CITY OF SANTA FE

Planning and Land Use Department Planning Commission Staff Report

Case No:	2025-11006
Hearing Date:	November 6, 2025
Applicant:	Forestar (USA) Real Estate Group, Inc.
Agent:	Liaison Planning Services, Inc.
Request:	Subdivision Development Plan
Location:	3800 Governor Miles Road
Case Mgr.:	Claudia Kath
Zoning:	R-5
Overlay:	Suburban Archaeological
Pre-app Mtg:	June 12, 2025
ENN Mtg:	August 22, 2025
Proposal:	Preliminary Subdivision Plat approval for 128 residential lots on 24.423-acres on 2 separate parcels: Tract #3A3 - 16.653 acres and Tract #3A4 - 7.77 acres.

Case #2025-11006. Vistas de la Sierra Phase 3. Liaison Planning Services, Inc., Agent, for Forestar (USA) Real Estate Group, Inc., owner and applicant (“Applicant”), requests review and approval of a Preliminary Subdivision Plat, per § 14-3.7(B)(3) of the Land Development Code, for a 128-lot residential subdivision in Phase 3 of the Vistas de la Sierra subdivision. The Phase 3 property is a 24.42-acre parcel located at 3800 Governor Miles Road and west of Richards Avenue. Phase 3 consists of 2 separate tracts. Tract #3A3 is 16.653 acres and Tract 3A4 is 7.77 acres. The subject property is zoned R-5 (reside

Figure 10 - Utility Map

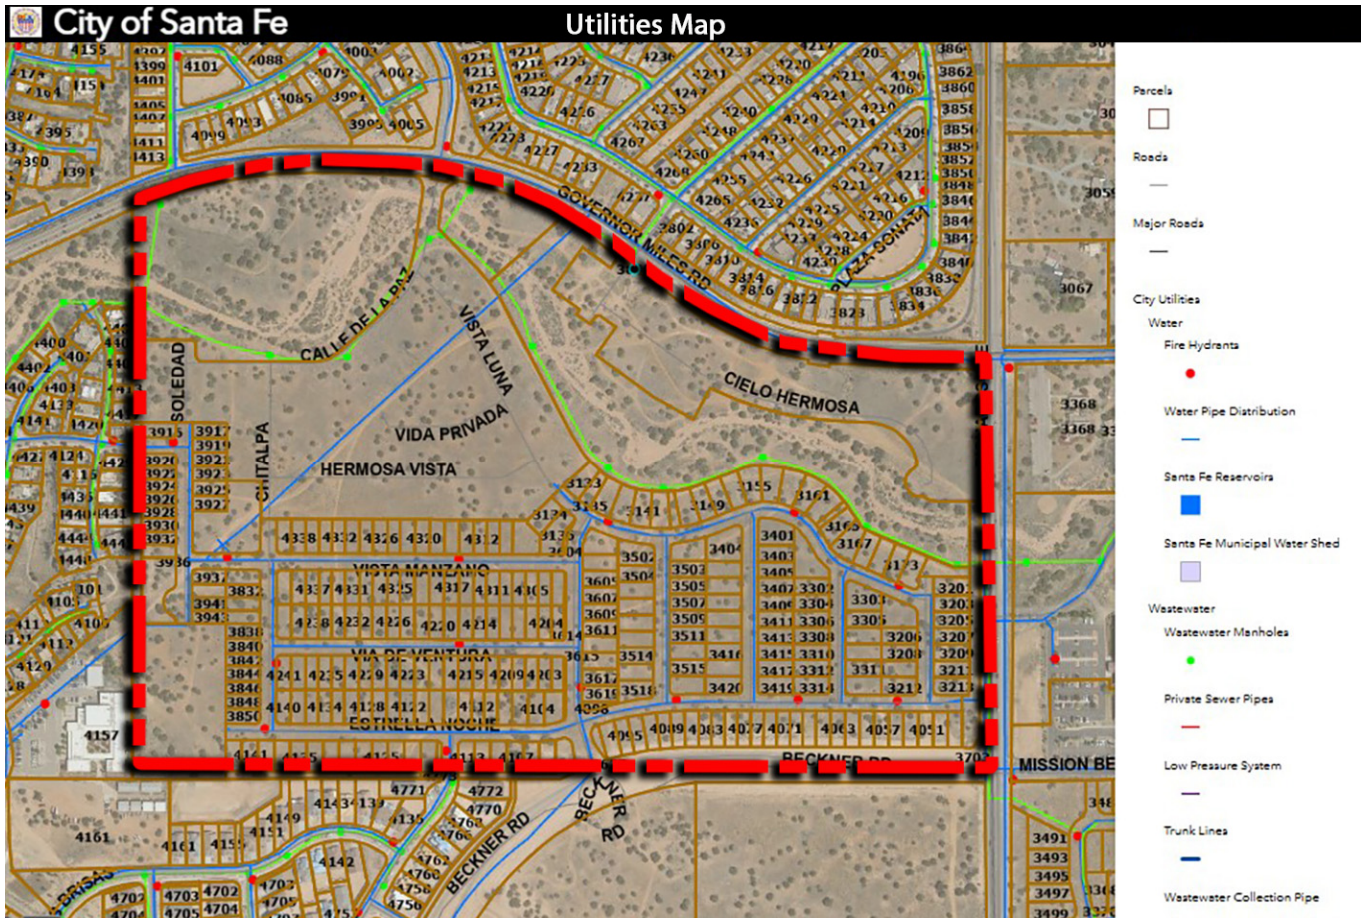
2. **Water & Sewer S FCC 1987, §25-3 & 4-** The Project will be served with City water, sewer, and dry utilities. There is an existing 16-inch water main between the arroyo and Governor Miles Rd. New drainage infrastructure, walls and ponds are proposed to be constructed over this main. Particular attention should be given to this area to not disrupt the water mainline. New 10-inch and 8-inch public waterlines will be constructed in the roadways connected to this line, as well as existing off-site water mains at the following locations: Governor Miles Road (two locations), Beckner Road, Richards Ave. (two locations), and Whispering Wing. New 8-inch public sewer lines will be constructed in the roadways, which will connect to the public trunk line adjacent to the arroyo. In addition, sewer connections are proposed at Viento del Norte and an existing line in Nava Ade. The Water and Wastewater divisions reviewed the Preliminary Subdivision Plat and the DRT Conditions of Approval and Technical Corrections may be found in Attachment A of this report.

Figure 11 - Grading Plan for Phase 3

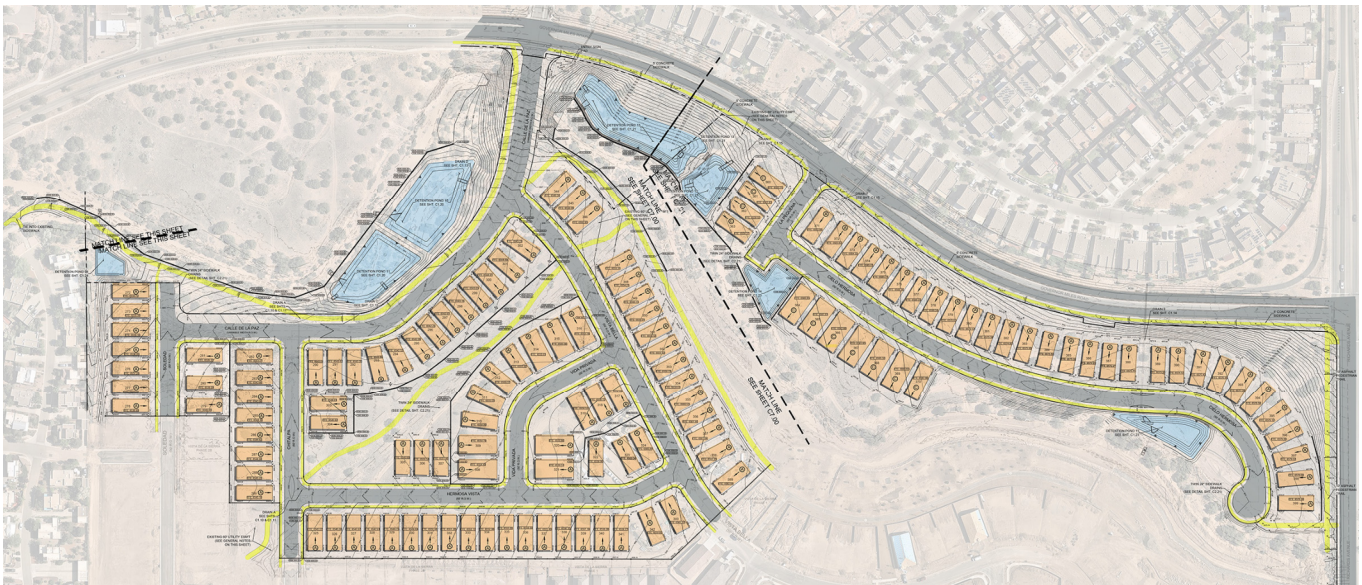
- D. **Terrain and Stormwater Management – SFCC 1987, §14-8.2** – the Land Use Technical Review Division has reviewed the Applicant’s submittal, and the DRT comments can be found in Attachments A & B of the staff report. Most notably, the DRT requests pond #9 be added back into the design, there should be a comprehensive Significant Tree survey (SFCC 1987, §14-8.4(F)(5)), and no plant material should be removed from the arroyo. The grading for the site sits below Governor Miles Road and the streets entering off of that road will slope down towards the arroyo to the housing area.

Figure 16- VDLS Phase 3 Trail joining Nava Ade trail

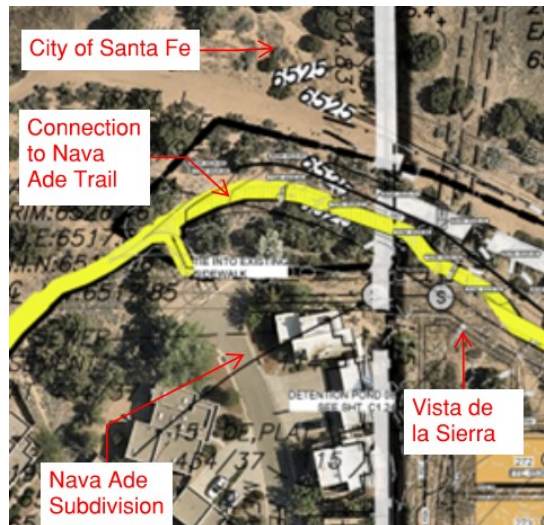
As part of the Project, the Applicant will construct sidewalks along Governor Miles Road. All streets within the overall Vistas de la Sierra subdivision will have sidewalks. The trail network will branch off of Governor Miles Road at Calle de la Paz and join the Nava Ade trail. The Vistas de la Sierra property ends to the east at the Nava Ade subdivision property line. The Applicant will continue the trail and join it to the existing Nava Ade trail. The Applicant shifted the trail to the north where it joins the trail in order to bypass existing landscape and sewer manholes.
